Improving Interoperability between Autoneg and Forced Mode PHY

February 9, 2014

Mike Tu

Forced Mode State Diagram Figure 97-27

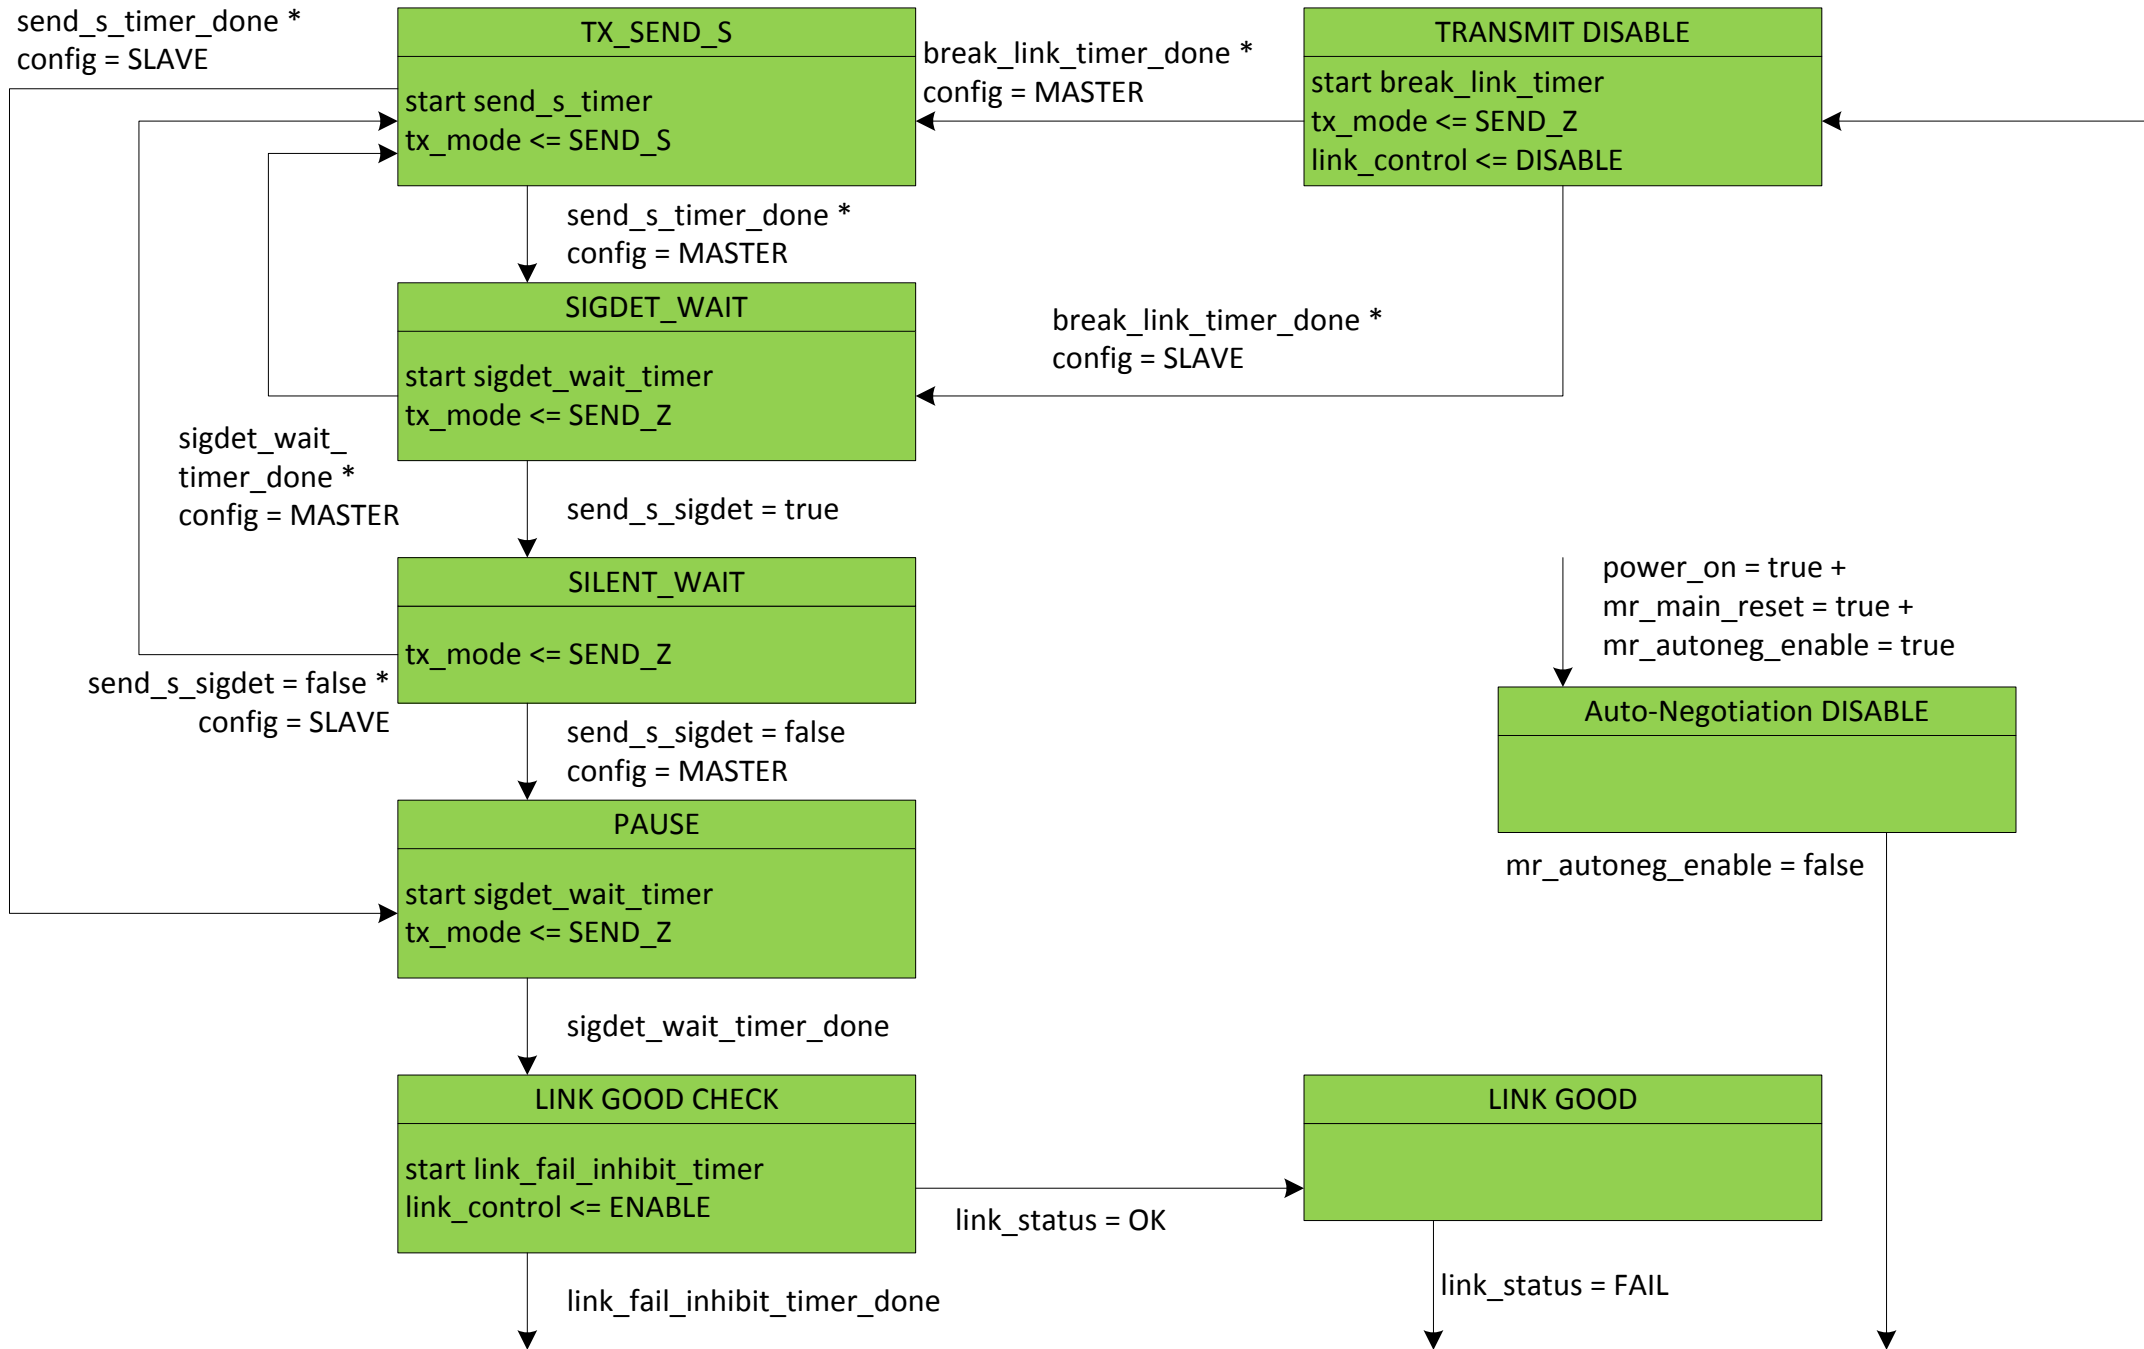
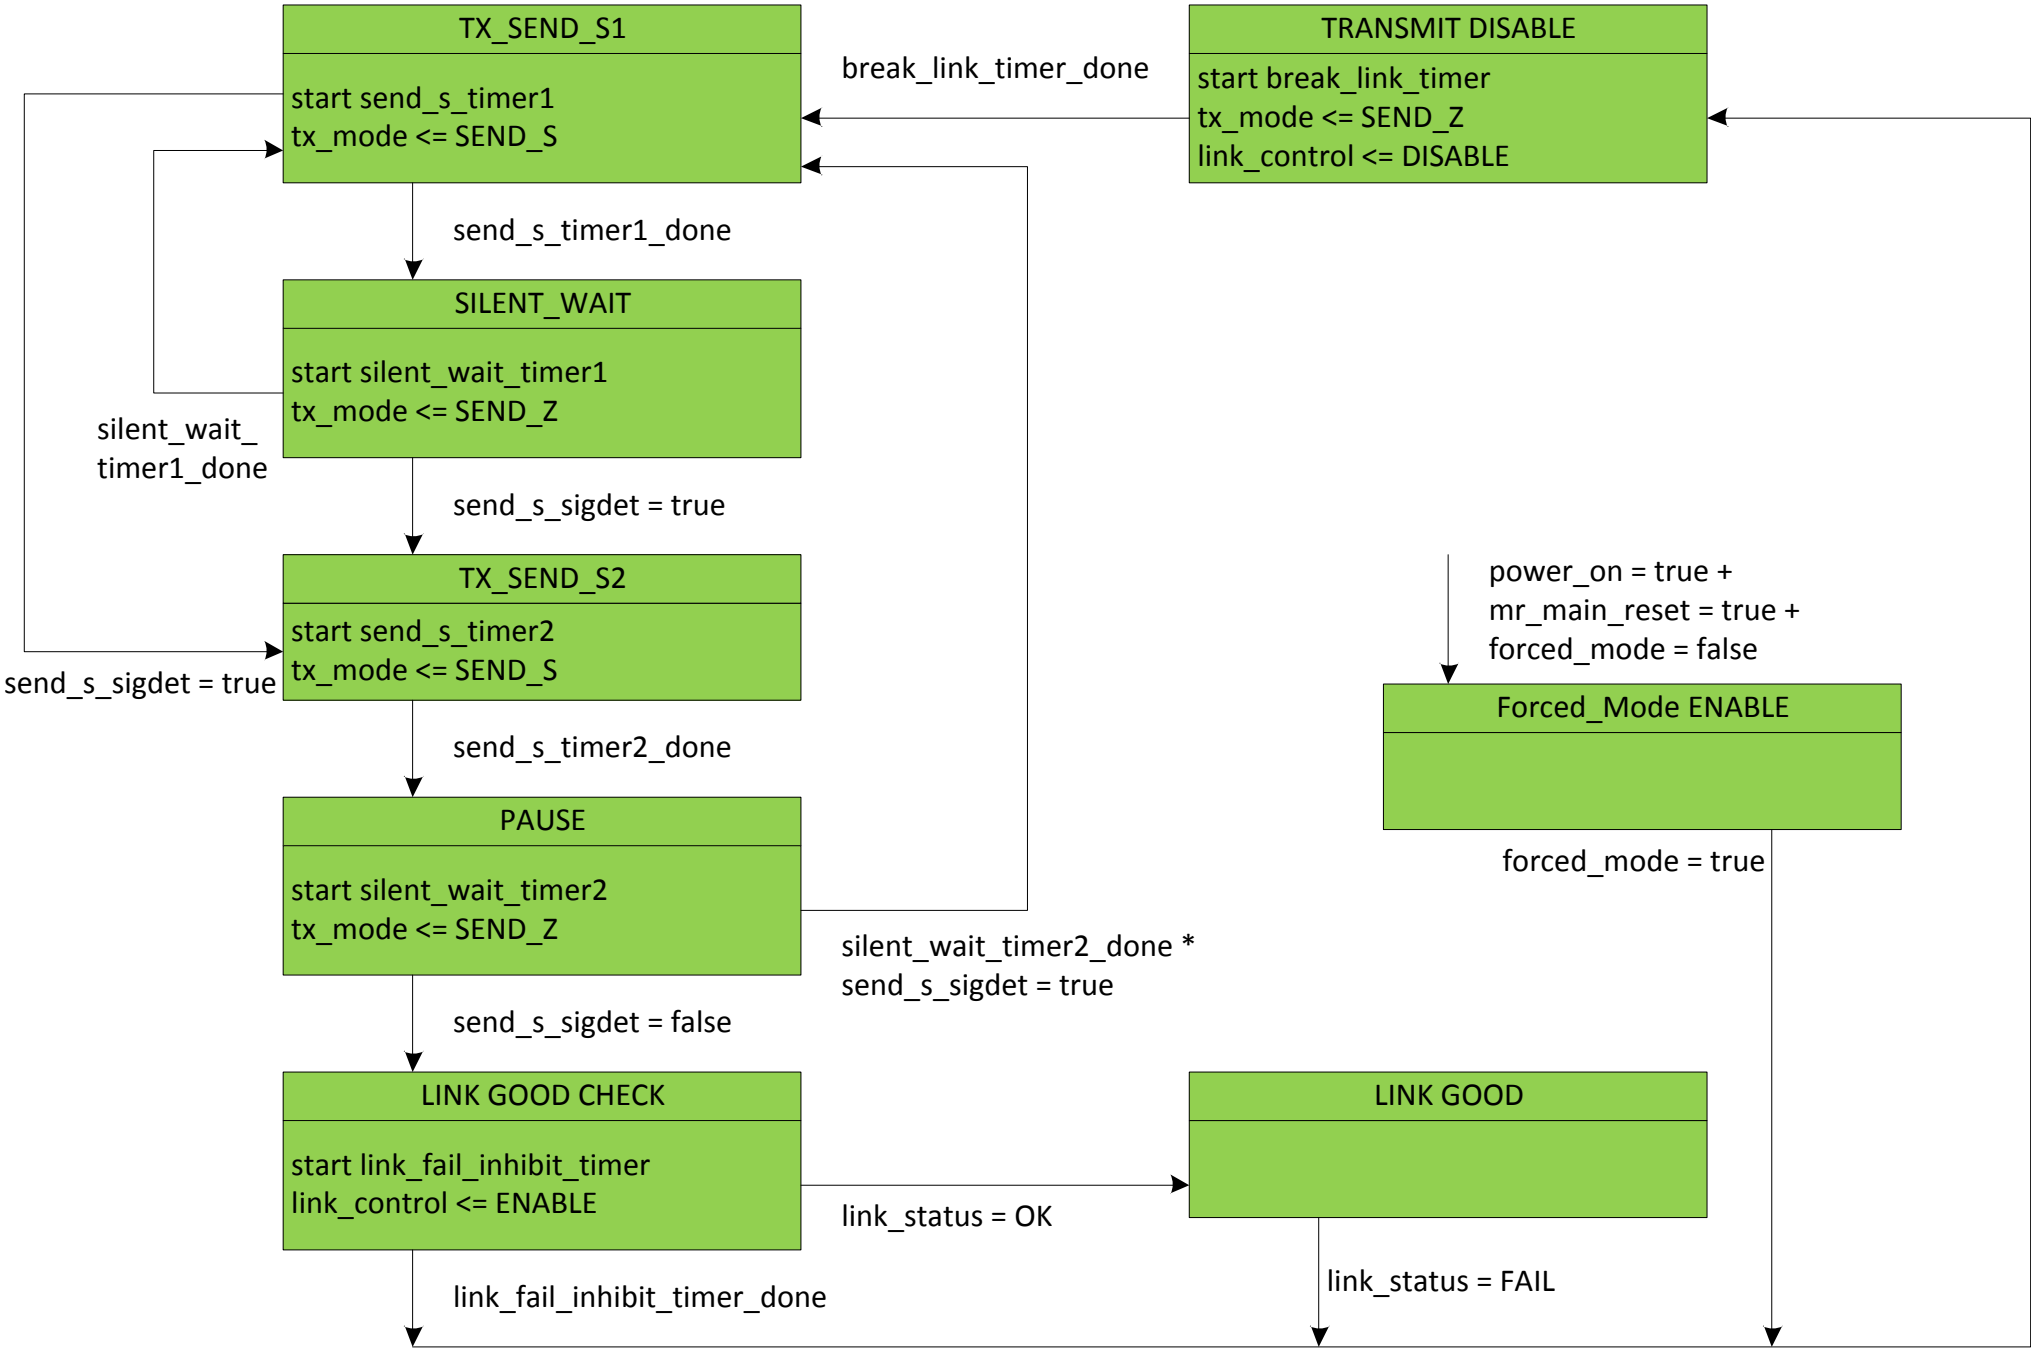
Changes to Figure 97-27

- Same state machine for MS and SL PHY
- SEND_S sigdet does not require turning off transmitter
 - This is always the case, but original state diagram assumes half-duplex.
- Synchronization is achieved when exiting the PAUSE state, when both transmitters are turned off
- Additional state variable “forced_mode”
 - When AN is disabled, default “forced_mode=true” after power_on/reset
 - When AN is enabled, default “forced_mode=false” after power_on/reset
 - AN state machine will set “forced_mode=true” if optional parallel detection sees SEND_S

Timers

- `send_s_timer1`: Timer used to control the duration `SEND_S` is transmitted during `TX_SEND_S1`. The timer shall expire $1.0 \text{ us} \pm 0.04 \text{ us}$ after being started.
- `silent_wait_timer1`: Timer used to control the duration of Tx silence during `SILENT_WAIT`. The timer shall expire $4.0 \text{ us} \pm 0.1 \text{ us}$ after being started.
- `send_s_timer2`: Timer used to control the duration `SEND_S` is transmitted during `TX_SEND_S2`. The timer shall expire $8.0 \text{ us} \pm 0.1 \text{ us}$ after being started.
- `silent_wait_timer2`: Timer used to control the duration of Tx silence during `PAUSE`. The timer shall expire $8.0 \text{ us} \pm 0.1 \text{ us}$ after being started.

New AN State Diagram (Fig. 98-14)

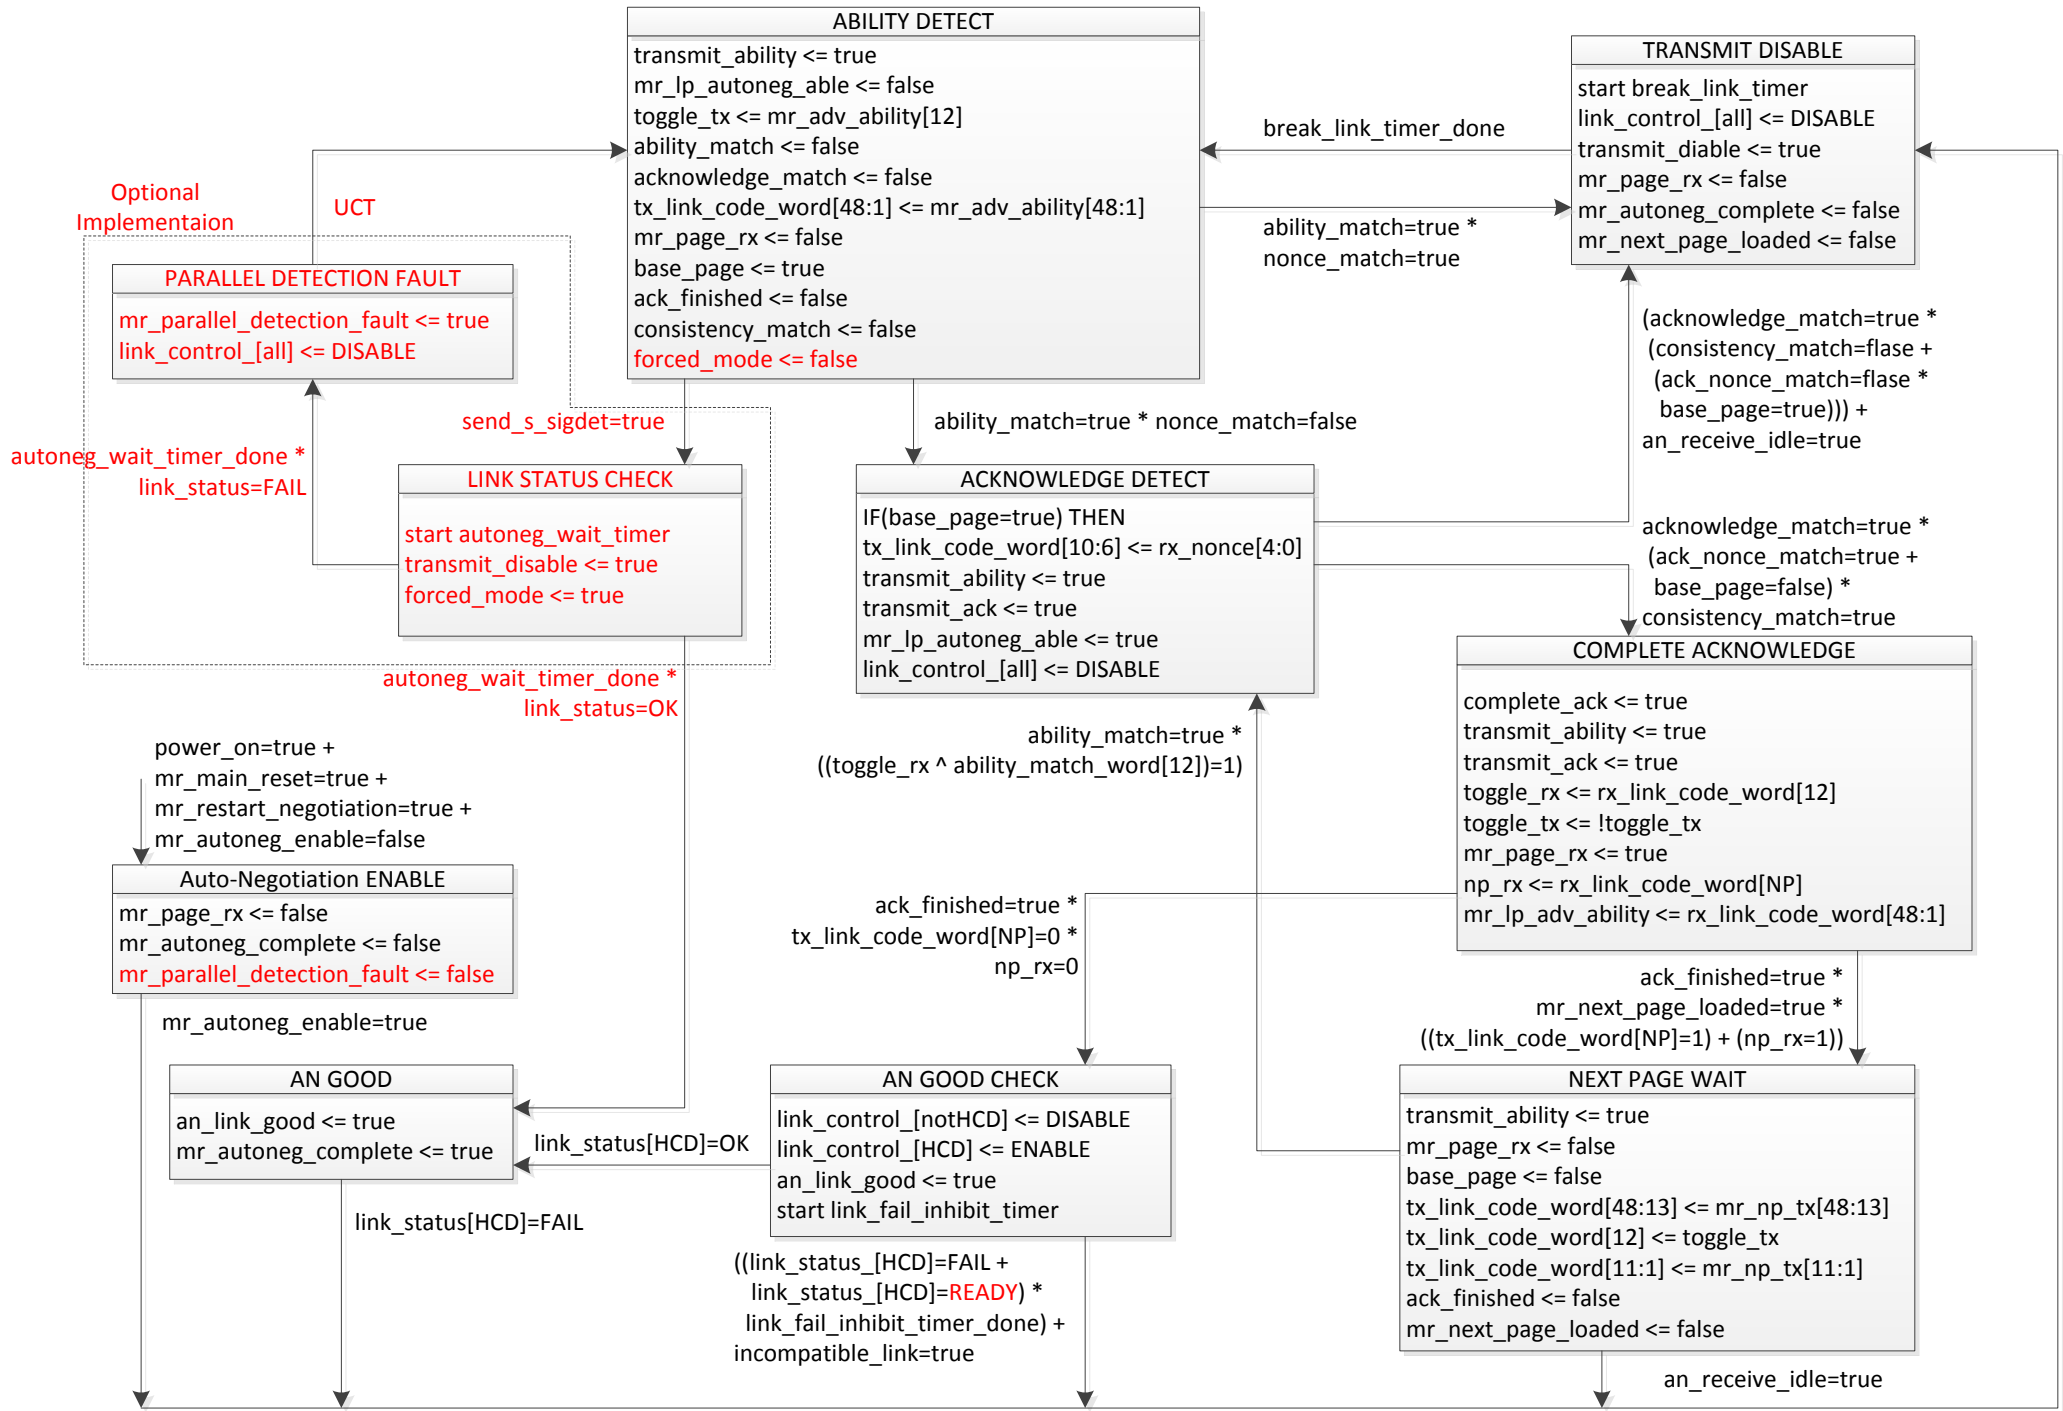
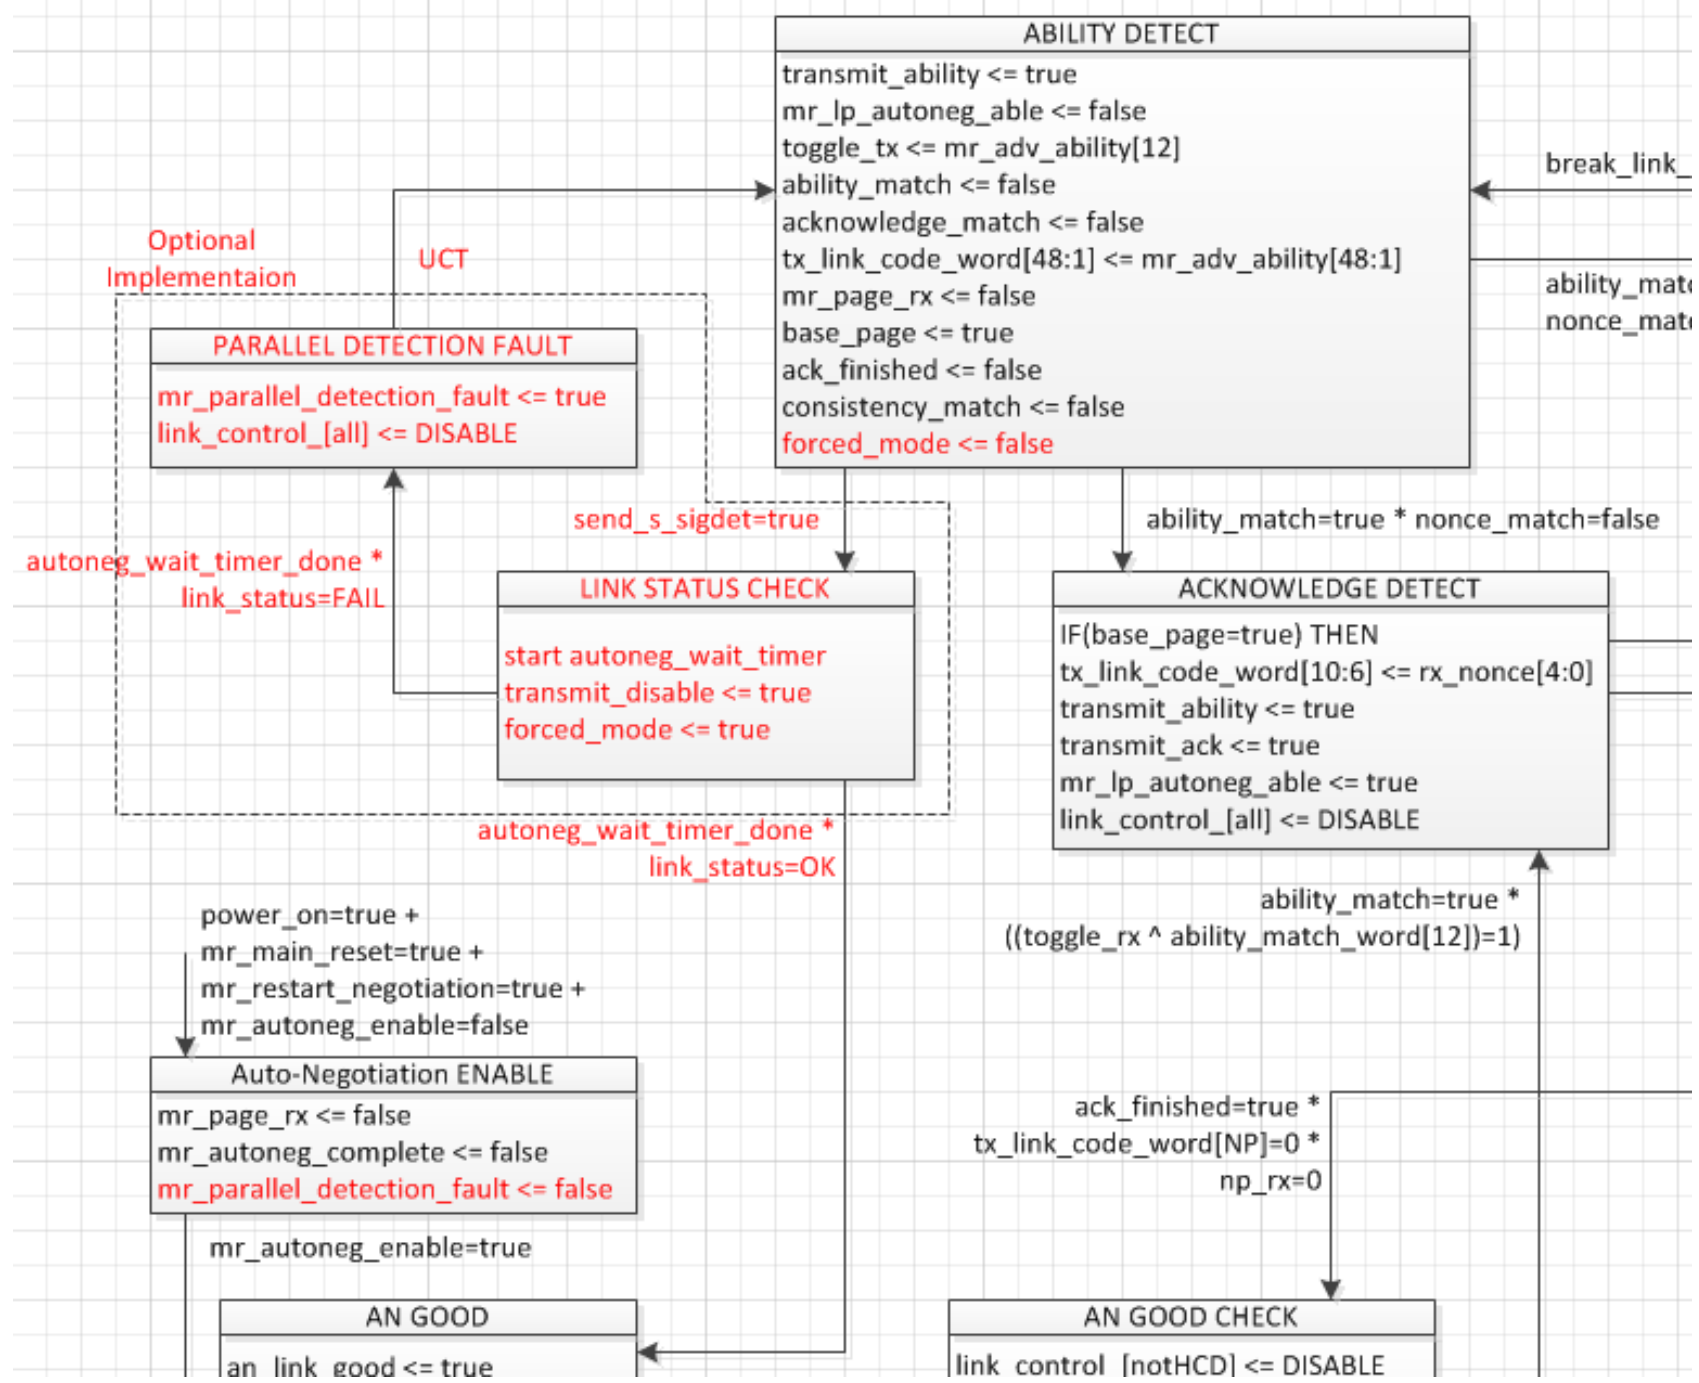
Changes to Figure 98-14

- Added new optional states “LINK STATUS CHECK” and “PARALLEL DETECTION FAULT”.
- In “ABILITY DETECT” state the PHY may implement correlation detectors for SEND_S(MS) and SEND_S(SL), in parallel to DME link pulse detector.
- If “send_s_sigdet = true”, then the link partner MS/SL configuration is resolved as well
- In “LINK STATUS CHECK” state the PHY will
 - Set “forced_mode <= true” to activate the forced mode state machine
 - Start autoneg_wait_timer and wait for normal training to finish
 - Transition to the “AN GOOD” state directly if link_ststus = ok.
- For PHY capable of both AN and forced mode, the state variable “forced_mode” determines which synchronization approach is active
